## ADDENDUM

NO. 01

**PROJECT NAME:** 2024 Cy Ranch High School Additions And Renovations

**PROJECT NUMBER:** 01818-06-01

SCHEDULE OF MATERIALS AND COLORS

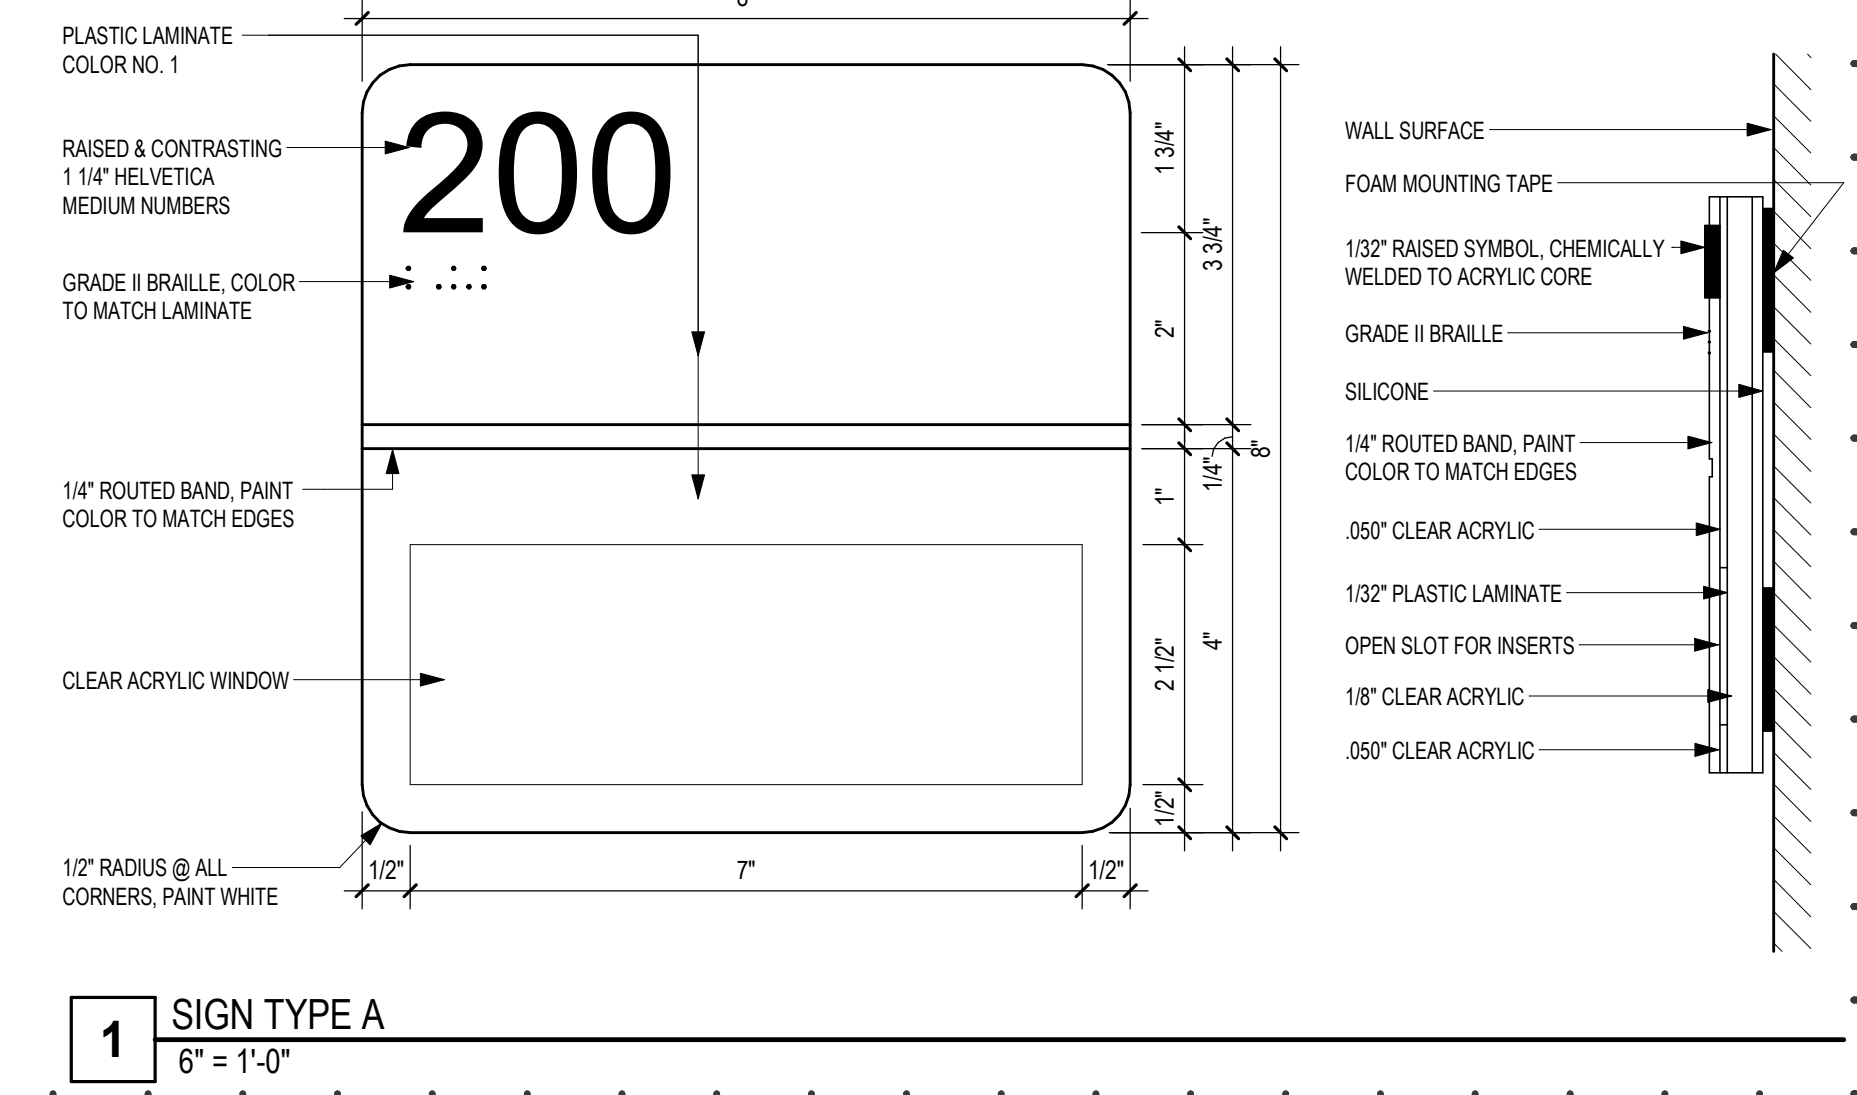
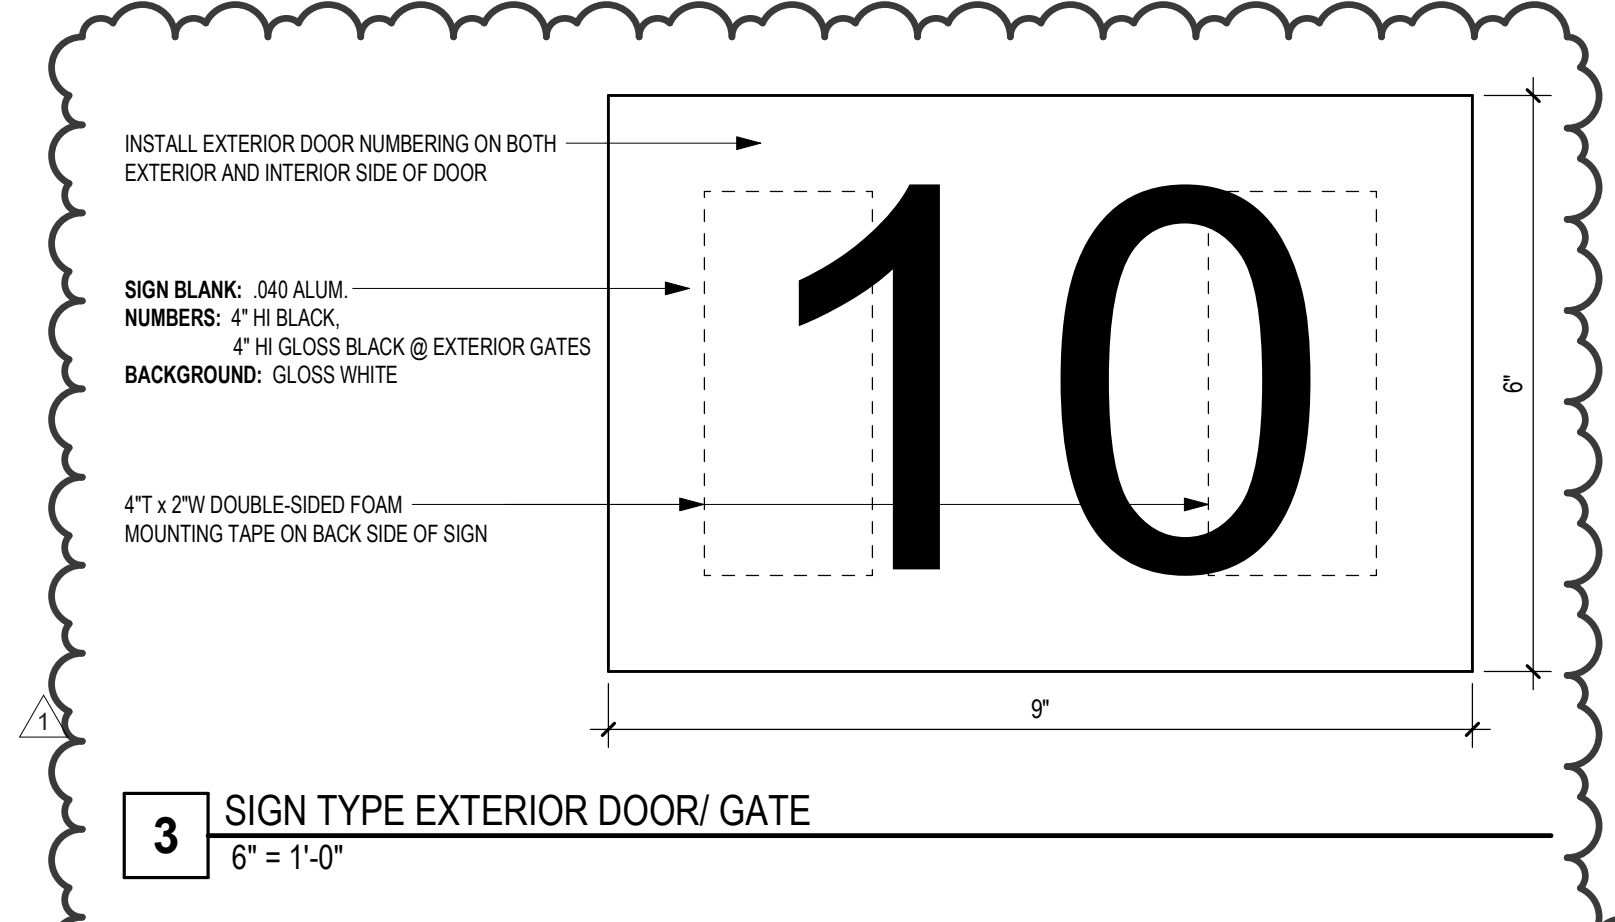
#### **AD No 1, Arch. Item 3: To the Drawings, Sheet G5.01, "SCHEDULE OF MATERIAL AND COLORS"**

- 1) Removed "CGB" Ceramic Glazed Base from Unit Masonry category
- 2) Revise tiling finishes per attached sheet
- 3) Add paint PT10 per attached sheet
- 4) Add details 1, 2, and 3 per attached sheet
